Wollongong Local Planning Panel Assessment Report | 29 August 2023

WLPP No.	Item No. 2
DA No.	DA-2023/50
Proposal	Residential - demolition of existing structures, tree removal and construction of a residential flat building including ten (10) units and associated basement parking
Property	4-6 Blacket Street North Wollongong
Applicant	ADM Architects
Responsible Team	Development Assessment and Certification - City Centre Major Development Team (NL)
Prior WLPP meeting	N/A

ASSESSMENT REPORT AND RECOMMENDATION

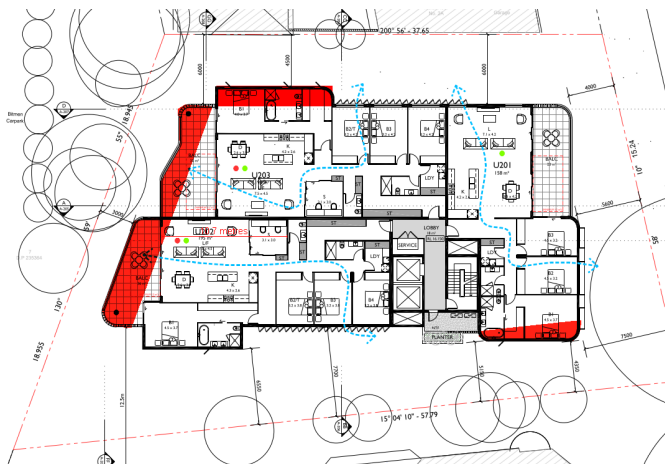
The proposal does not comply on the southwest corner, northeast corner and rear as illustrated below.

There are no particularly unique circumstances.

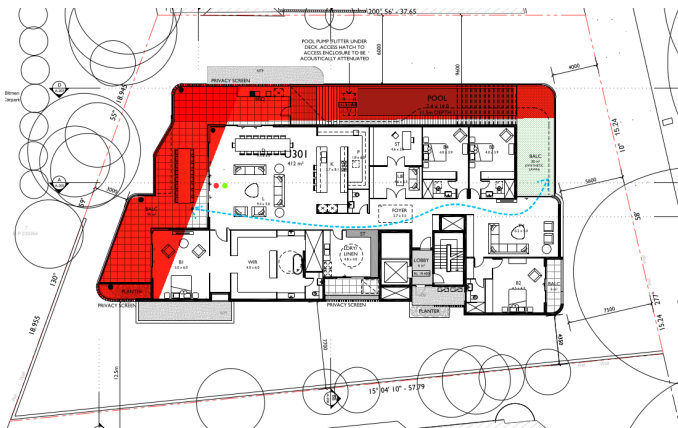
The upper portion of the top floor also does not increase setbacks as recommended as illustrated below.

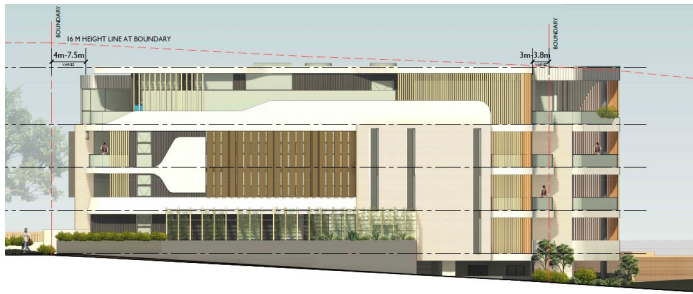
A comparison of the proposal with adjoining existing or approved development is provided below.

The 4m setback is not out of context with the adjoining developments. It is noted the building immediately to the west has closer setbacks and that the built form setback increases towards the rear which facilitates greater solar access to that development. The approved form to the east has reduced setbacks and a largely defensive facade

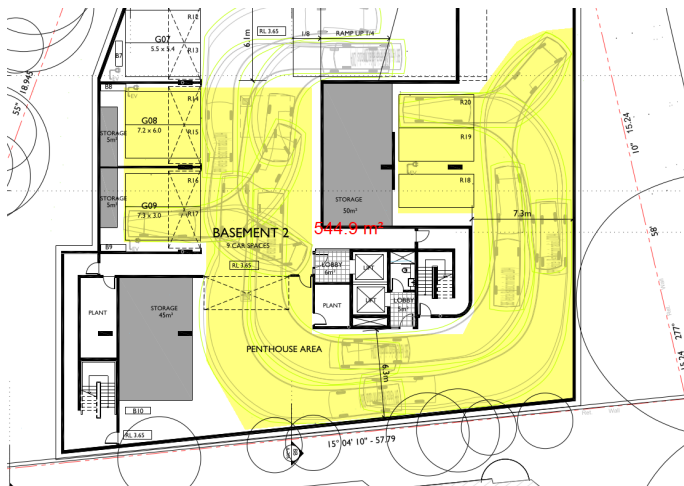
The applicant has identified 7 spaces (2.4 x 5.5m) as being included as gross floor area as shown below

The contribution to FSR based on the above is 117m² (basement 1) and 37m² (basement 2).

The way this has been quantified is not supported. The seven spaces should be located adjacent one another and the access to those space also included. This could look more like the image below and equates to somewhere in the order of 545m².

Fig 2:

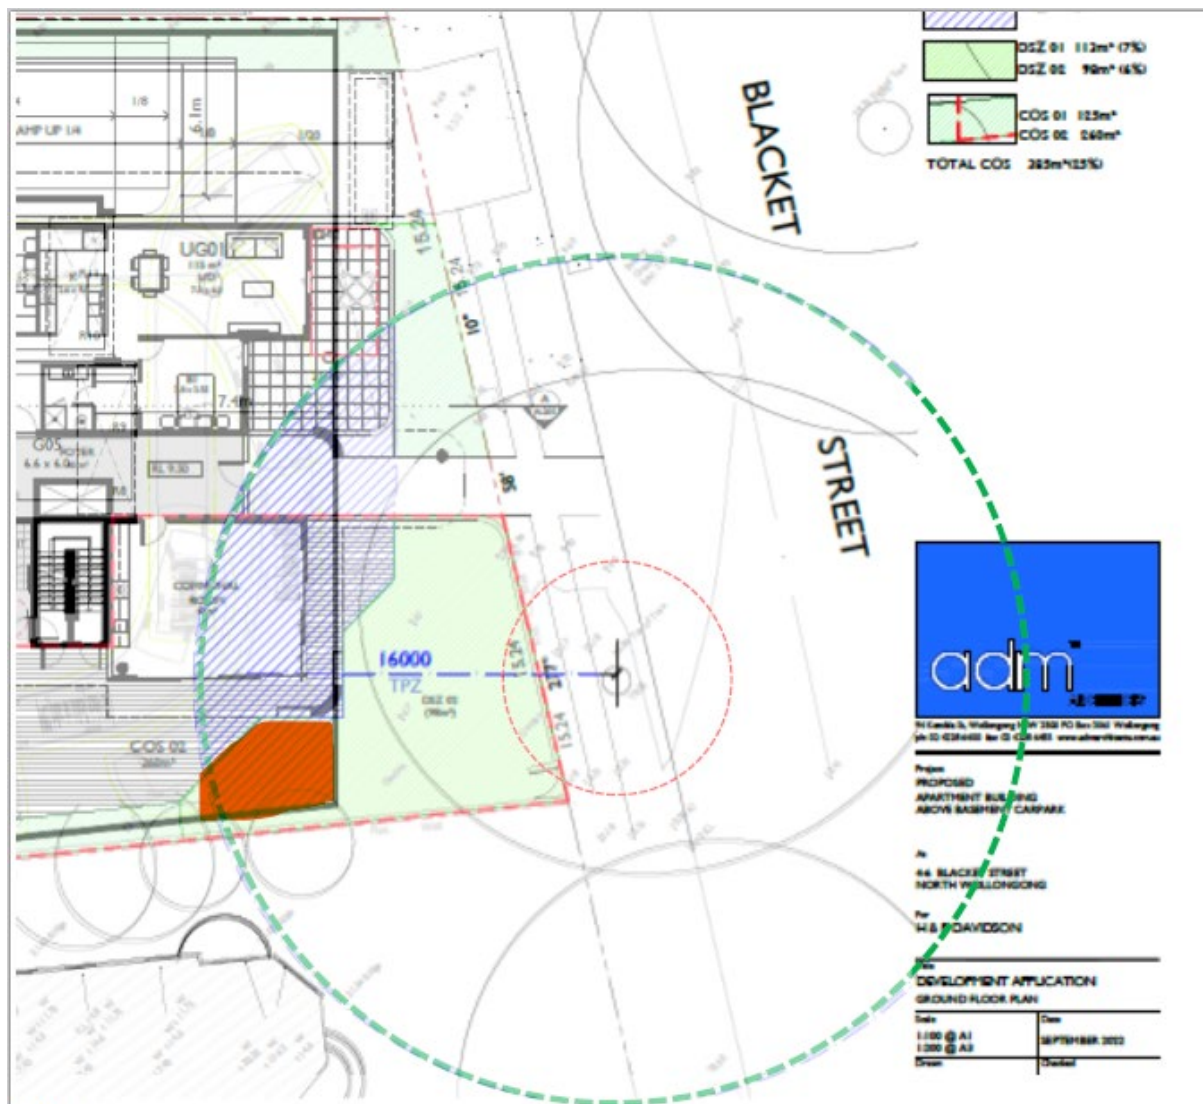
The Arborist Report does not accurately show the extent of encroachment of the basement into the TPZ as illustrated in red below.

Fig 2:

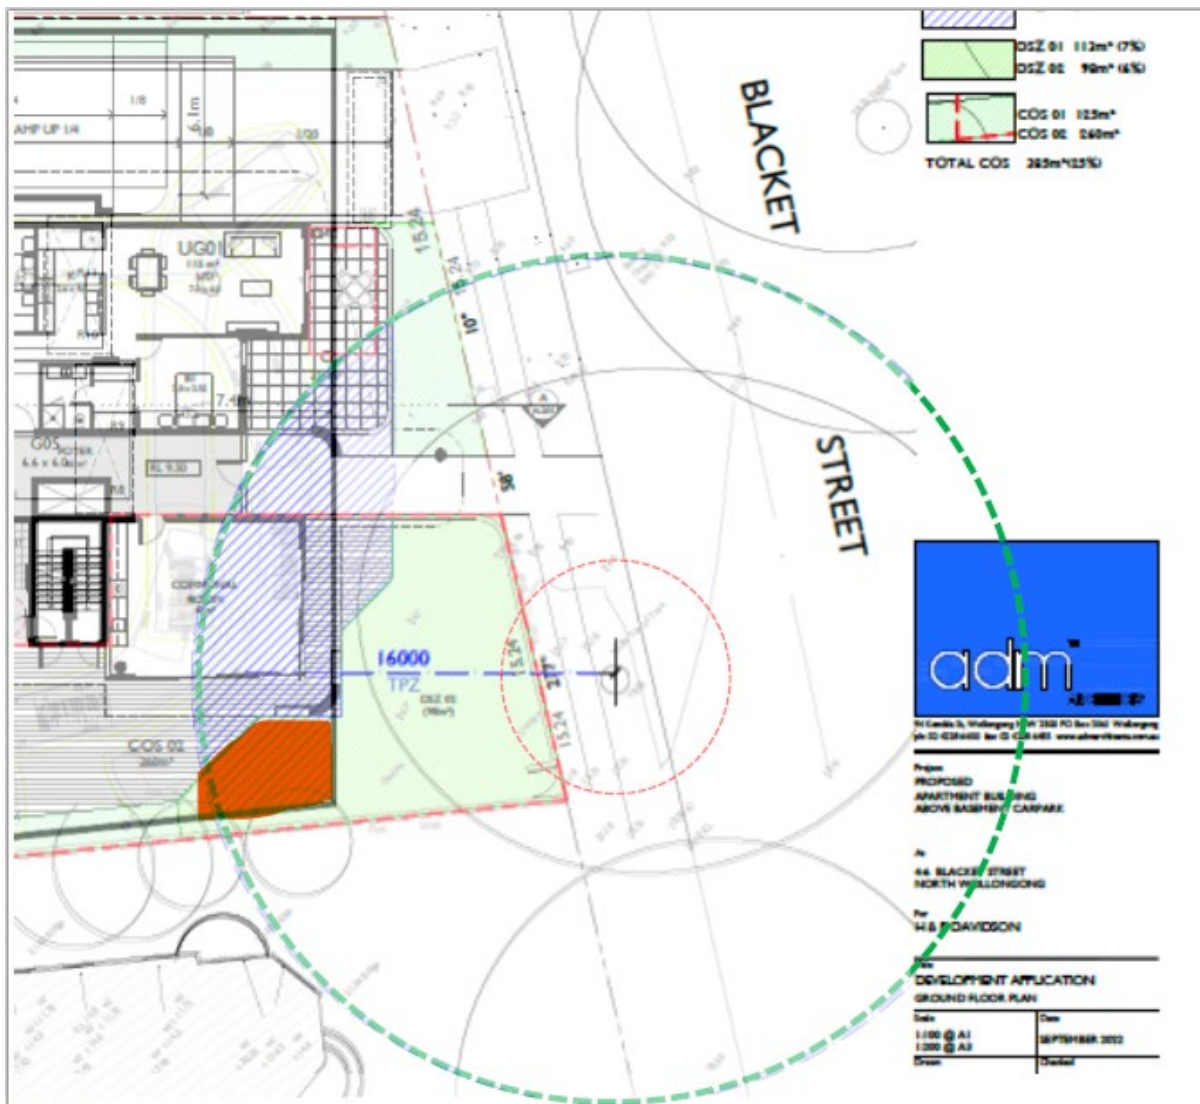
The Arborist Report does not accurately show the extent of encroachment of the basement into the TPZ as illustrated in red below.
